Landscape Design Evolution Statement – Site Wide Comparison Table

Tree Planting Strategy – Coordination Review

This document has been prepared to explain the evolution of the approved tree planting proposals and to justify amendments made through the detailed coordination and technical stages.

Tertiary road – Parking to 271-279

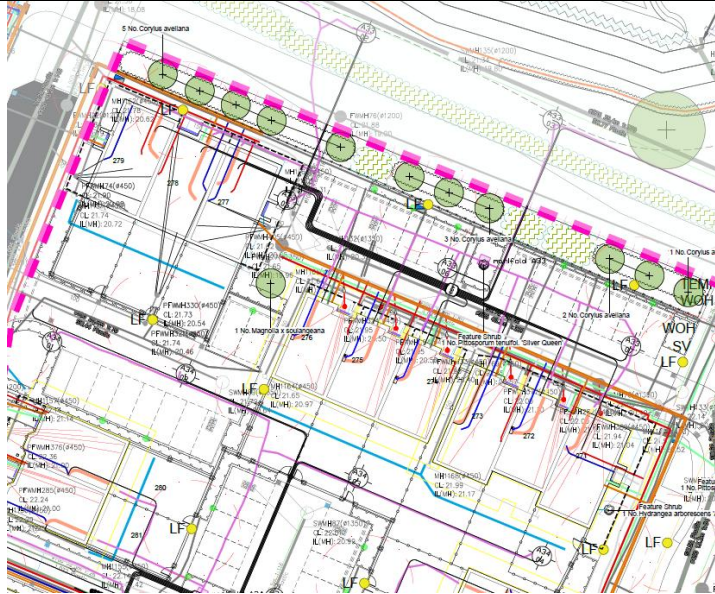
The tree planting has been retained along the new native hedgerow on the northern boundary.
The tree shown between the bays (front of plot 274) has had to be omitted due to heating main manifold (see screengrab right hand side column) placed on the middle of the planting bed. The tree shown on the edge of the parking area was omitted due to lighting constraints.

A small tree has been proposed between plots 276-277 to improve street setting – small tree due to soil volume available and water demand constraints

Parking court – 280-286

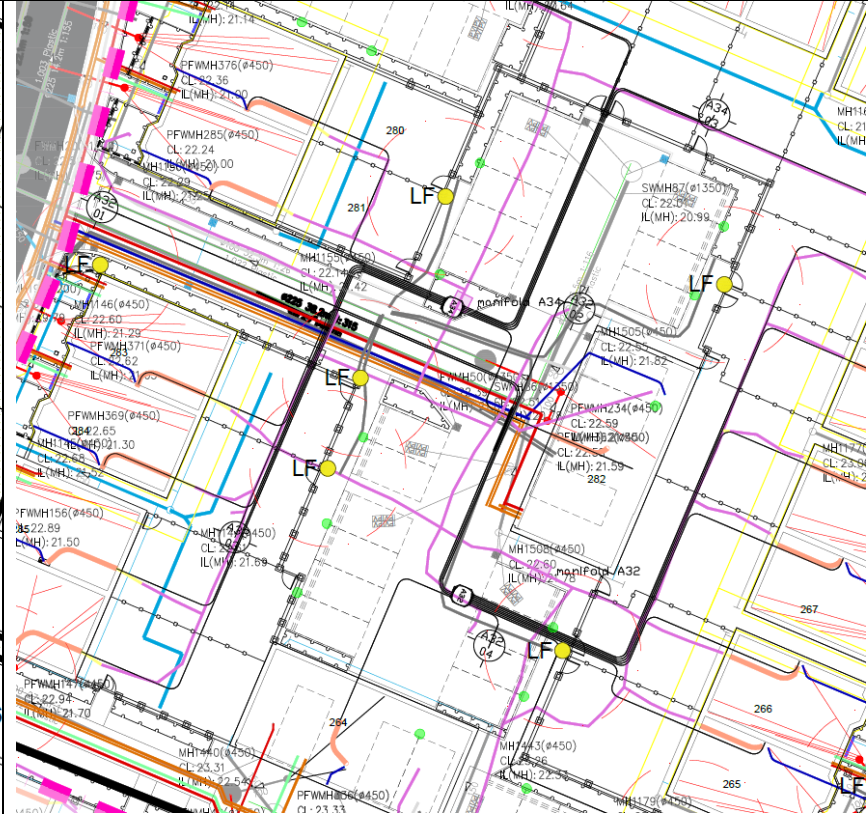
Tree planting within this courtyard was reduced due to insufficient soil volume and below-ground service constraints identified during detailed coordination. The 4 trees shown on the Tyler Grange drawing to be planted within hard landscape have been omitted from original proposals. At this stage the soft landscape beds were also omitted. These soft landscape areas have subsequently been reinstated and planted in accordance with the coordinated landscape proposals.

The two main trees near the edge of the parking court omitted due to soil volume and Ground Source Heat Pipe (GSHP) manifold. All trees shown previously have been omitted due to clashing with GSHP connections and lighting.

Main Road

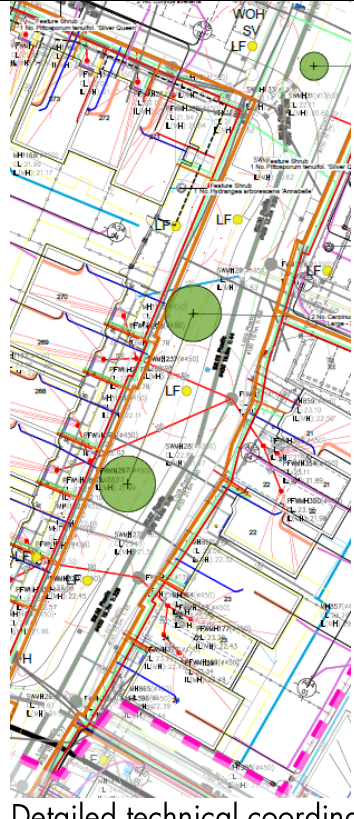
The preliminary DD work included trying to follow a similar approach as shown on Tyler Grange in terms of numbers albeit reduced due to lighting columns and visibility splay information.

Detailed technical coordination and construction-stage constraints reduced the achievable tree provision within this section to two Hornbeam trees. Final tree locations were influenced by drainage infrastructure, water connections, lighting columns, visibility splays, root barrier requirements, and the available soil volume achievable alongside existing underground services.
